NEEDHAM WRIGHT LASKEY
ENGINEERS INC.
10290 MONROE DRIVE
SUITE 305
DALLAS, TEXAS, 75229
PH. 214 357 2981 SHEET NO. 4

UTILITIES PLAN						
PERSONAL WAY AVIATION						
TOWN OF ADDISON, TEXAS						
DRAWN	DESIGN	DATE	SCALE	NOTES	FILE	NUMBER
NWL.	NWL.	9-18-91	1"=40'

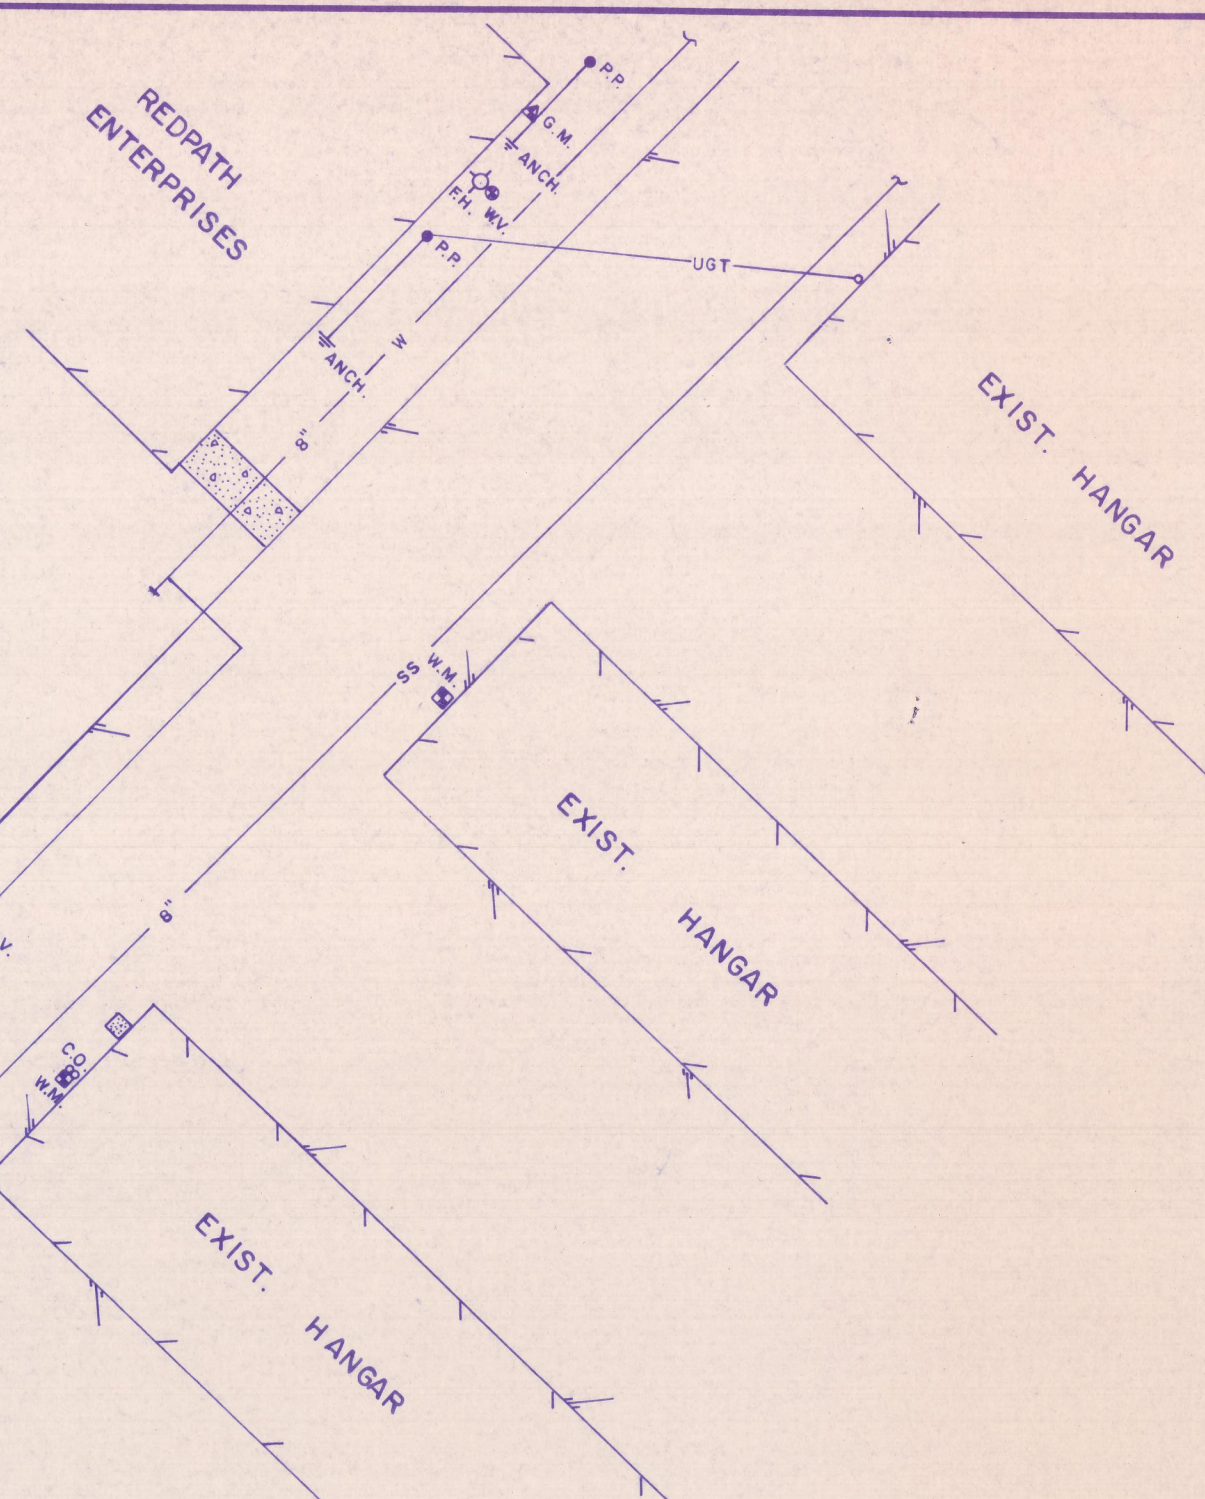
*SHOW DEPTH OF M.A. f
PIPE 2'-1" over
EXIST. SS. LINE!*

DOUBLE CHECK VALVE!

FIRE LINE?

*is this
EXIST. ALSO?*
